In accordance with the Commission's 'Additional Material' policy my family and I would like to comment on the new material that was provided to the Commission on 2nd June 2021.

I will now comment on the Dept. of Planning, Industry and Environment's response to request for information dated 2nd June 2021. The Department's response could only be described as disingenuous!

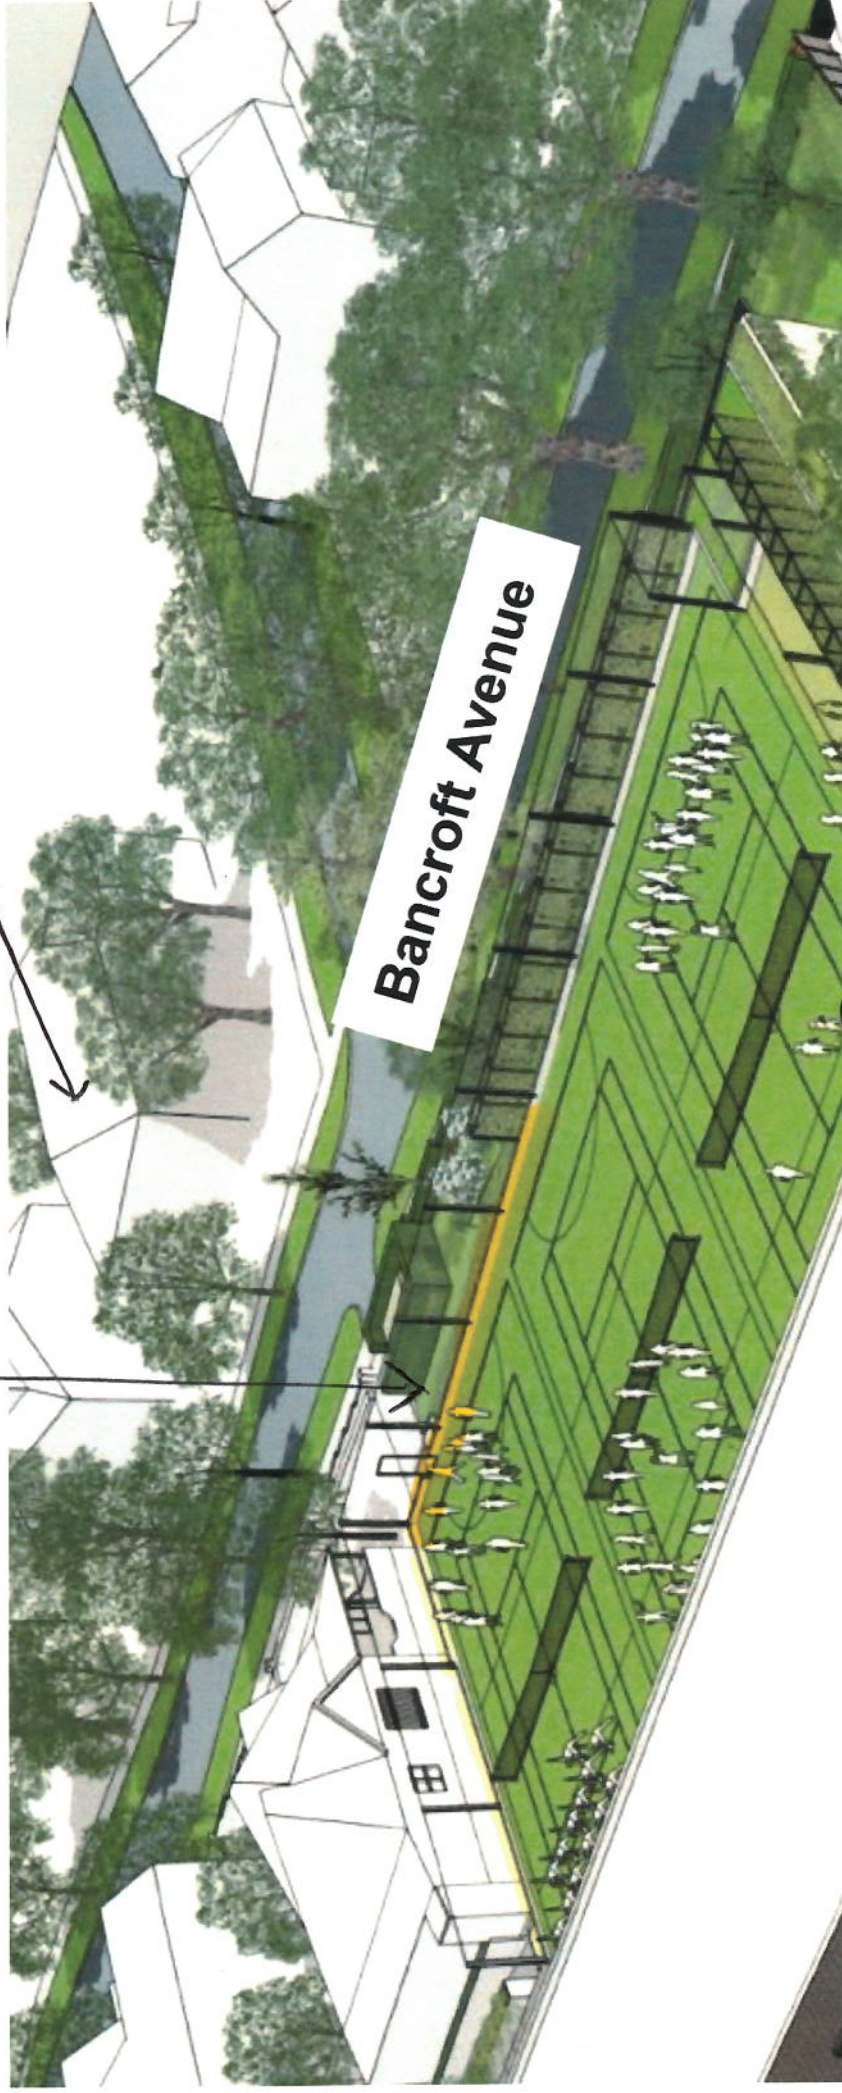
When looking at the plan the Department fails to mention that the steel trellis only extends approx. half way along the proposed Bancroft frontage.

In fact the Departments letter is deceptive because the two illustrations that were provided make it look like the steel trellis extends all the way along the length of the development facing Bancroft Ave but it does not. The steel trellis does not surround the sports courts, as the Department would like the Commission to believe.

Behind the Roseville College sign you can clearly see that there is no steel trellis and that the barrier will be fully visible not partially visible as stated by the Department (the barrier will be visible through the 3.3. metre wire fence)

No screening to Bancroft Ave
No steel trellis
No landscaping

28 Bancroft Ave (also referred to as heritage listed item 199)

No screening to Bancroft
